Docket Number:	23-OPT-01
Project Title:	Fountain Wind Project
TN #:	253384
Document Title:	Jim Wiegand Comments - Against Fountain Wind #7
Description:	N/A
Filer:	System
Organization:	Jim Wiegand
Submitter Role:	Public
Submission Date:	11/29/2023 3:25:11 PM
Docketed Date:	11/29/2023

Jim Wiegand Comments - Comments Against Fountain Wind #7

Comments on the Fountain Wind Project Draft Environmental Impact Report

Turbine site locations and critical habitat avoided in DEIR research.

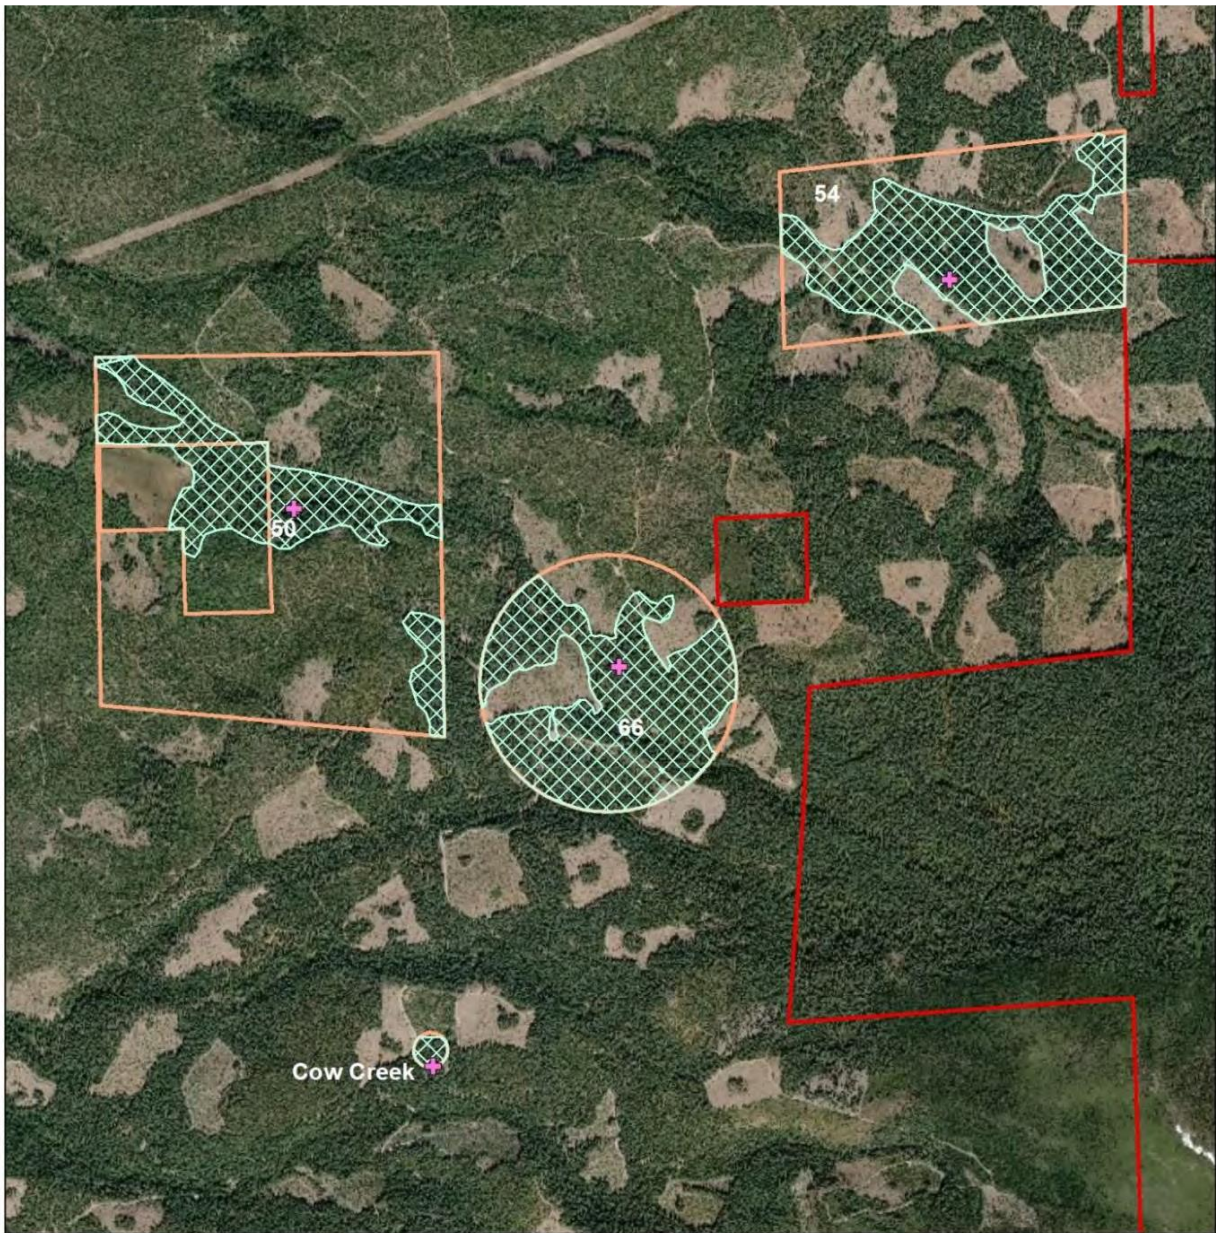
No Goshawk nesting or nesting territories were reported in the DEIR. This information tells me otherwise. But DEIR studies were deliberately **created to avoid** the most favorable habitat. Habitat well with the mortality footprint of both wind projects. There could be active nests 100 yards from turbine sites near MF3g and MF6g. But if research avoids looking, the public would never know.

**DEIR research avoided critical Spotted owl
and critical Goshawk habitat**

Figure 3.4-4
Spotted Owl Territories in the
Hatchet Ridge Wind Project Region

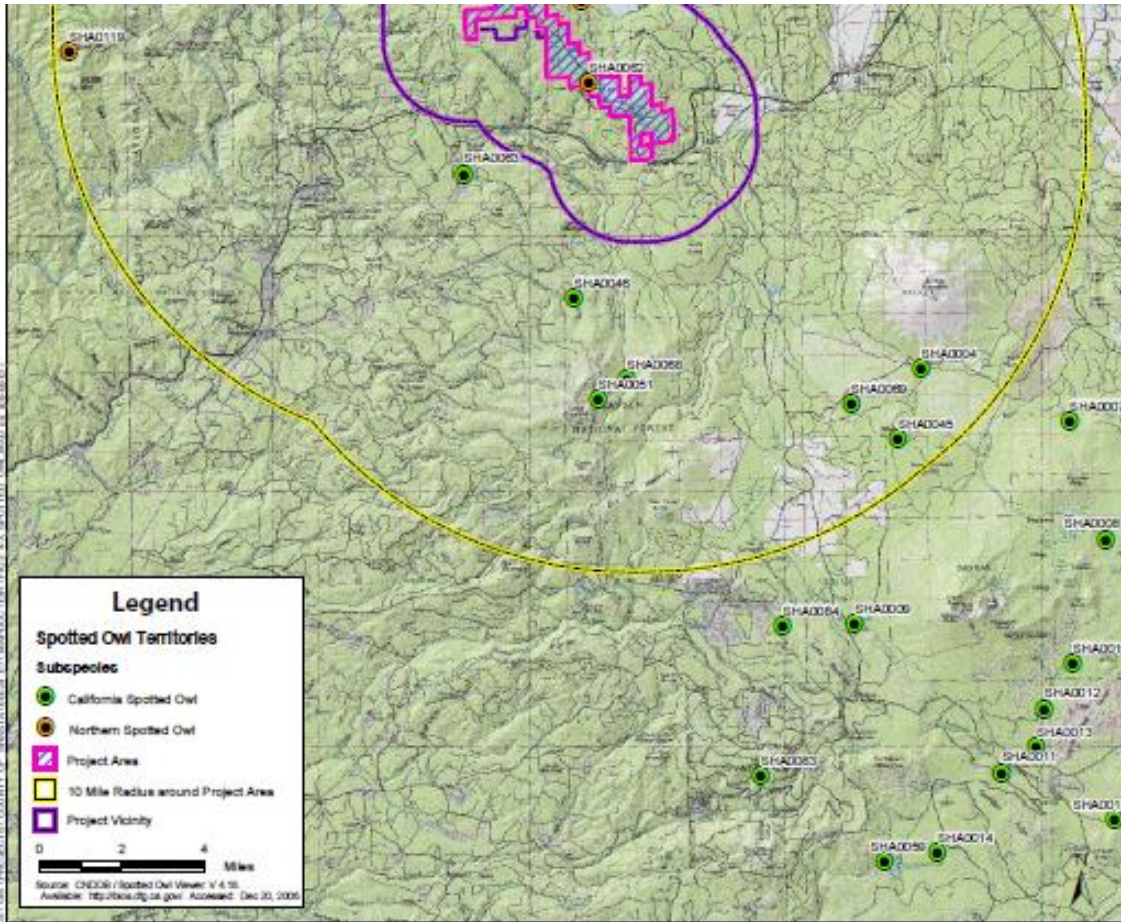
Besides the Fountain fire burning some of this owl habitat, what has happened to all these spotted owl nesting territories reported in the Hatchet Ridge EIR?

The Fountain Wind DEIR does not say

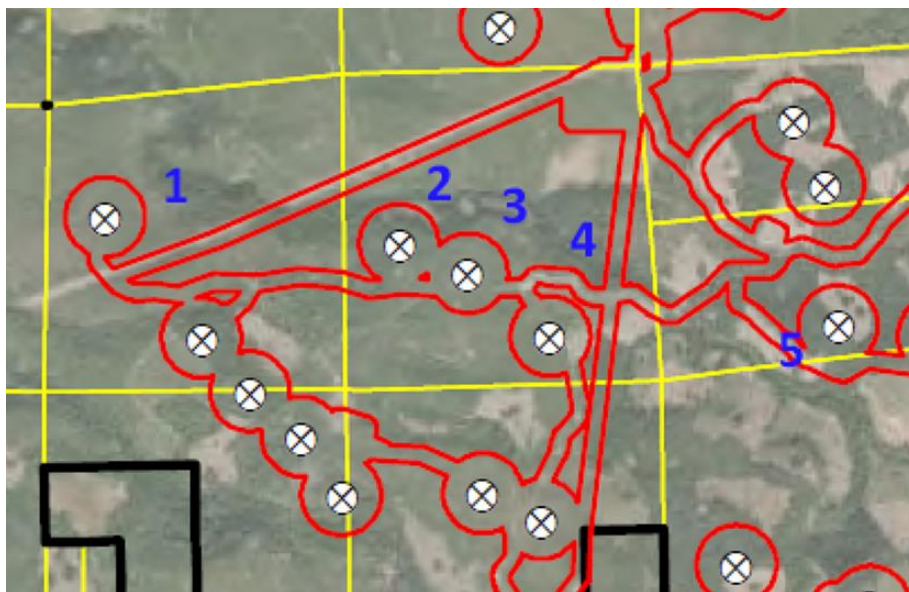
Not True - Five massive turbines will be located along this creek location (see image).

If the Bat Acoustic survey had positioned all their equipment in open areas near water with clearings, the total bat passes in this survey would have easily been several hundred thousand. The MF3g site shows this. Wind Biologists also know this and when bat surveys are conducted, they try to locate equipment away from the best bat feeding locations. I have examples that show this research pattern in other studies. Of course, the bats living near MF3g will be annihilated by at least 5 of the Fountain Wind turbines, that will be locate along this creek site.

Figure 2. Eagle and other raptor nest locations documented during aerial surveys for the Fountain Wind Project, March 20 and May 9, 2017.

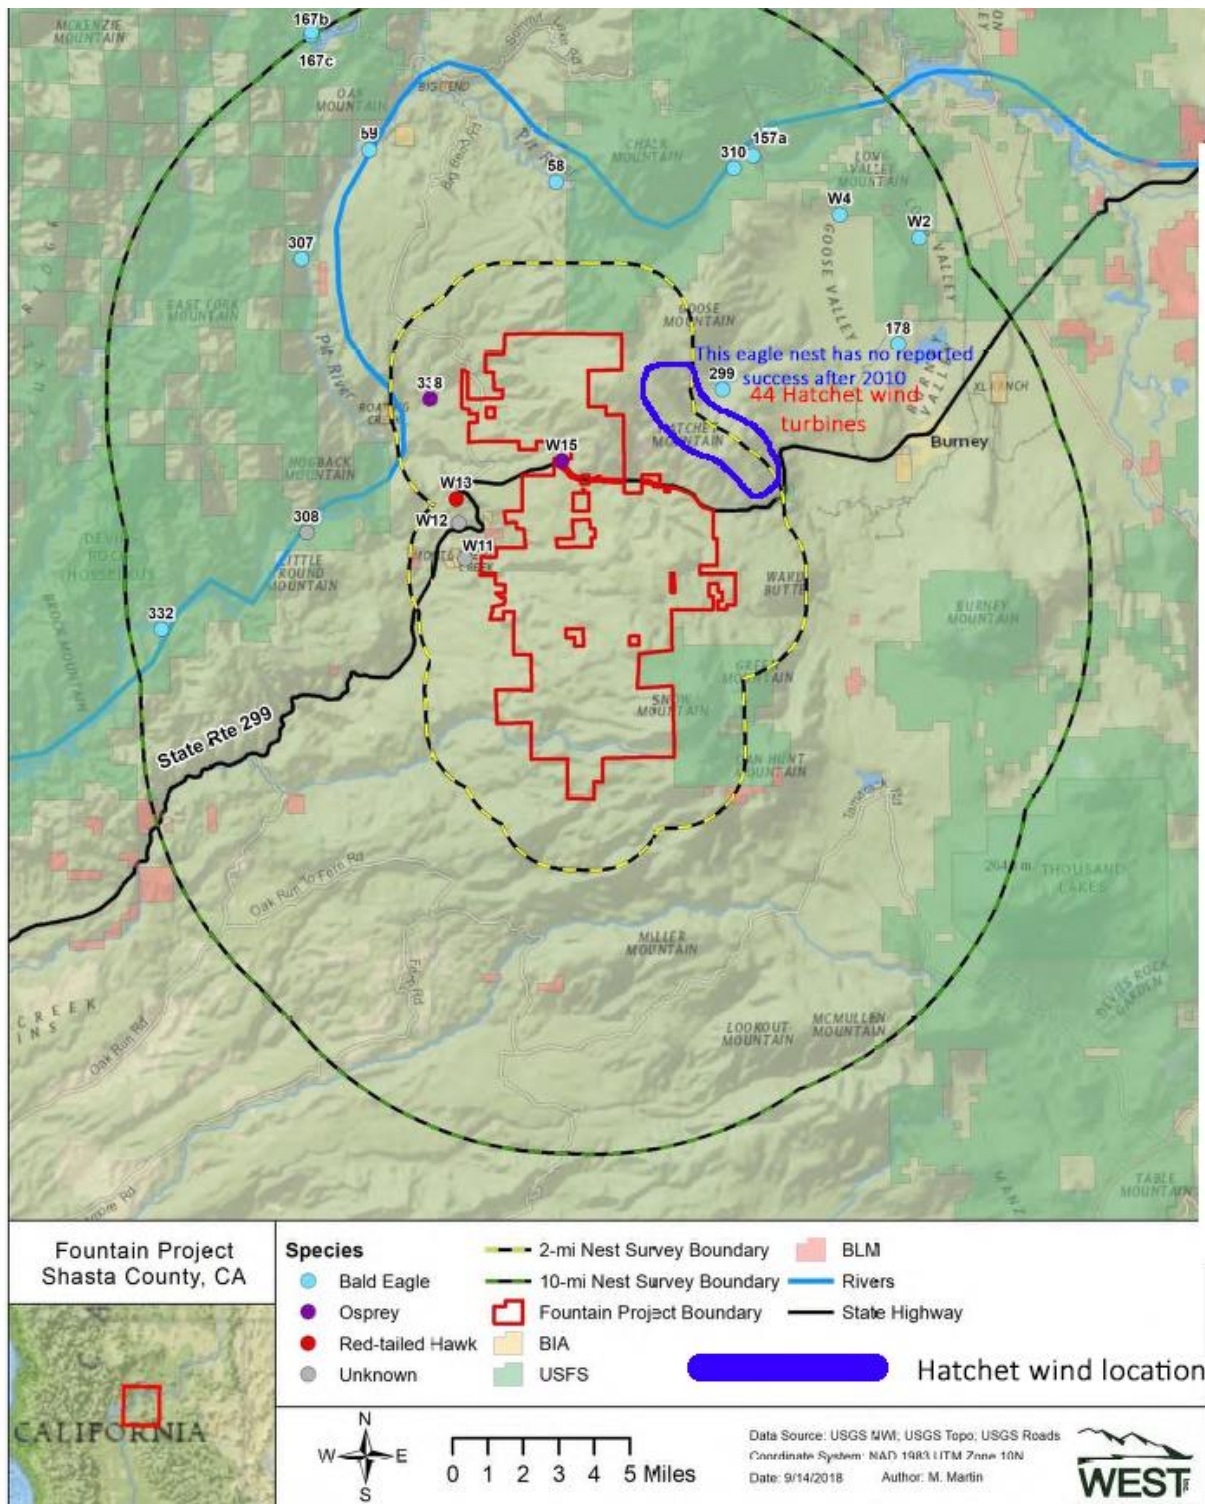
Now, 10 years after the Hatchet Ridge wind turbines started spinning, the Fountain Wind DEIR reported one occupied raptor nest, within 5 miles of these turbines with no credible explanations. Since 2010 bald eagles attempting to

nest at Margaret lake, are very likely being killed off every year.

Figure 7. Locations of raptor nests within two miles of Hatchet Ridge.

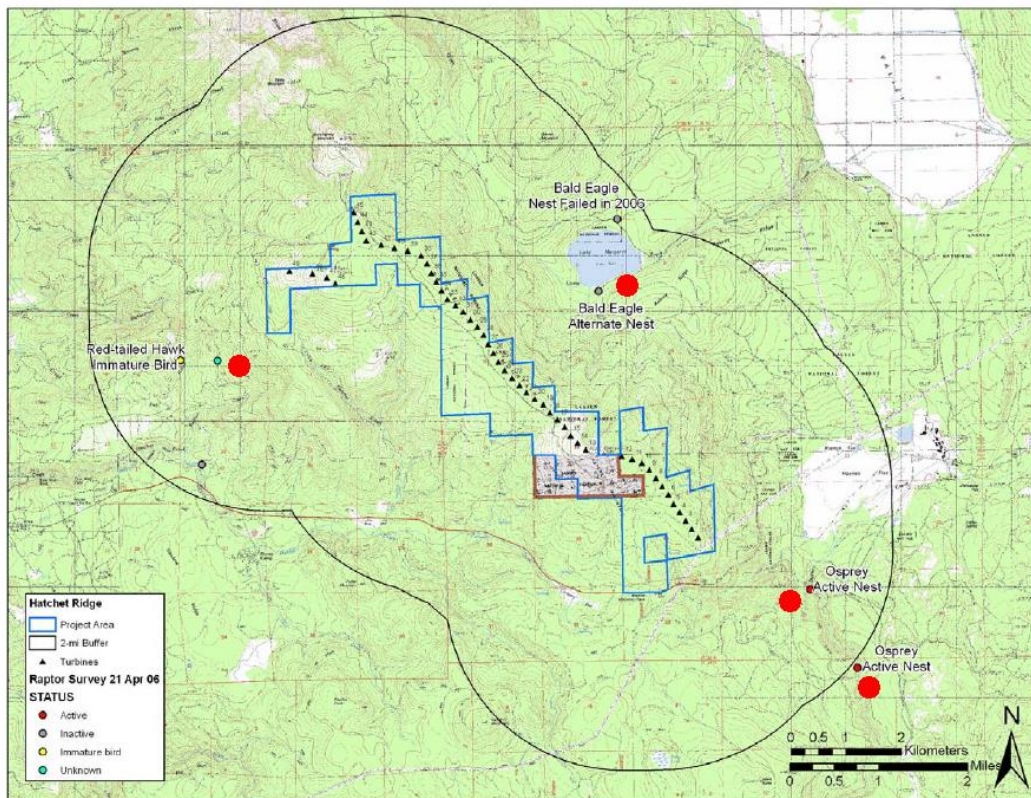
What has happened to these nesting territories since 2010 after 44 Hatchet ridge turbines became operational ???
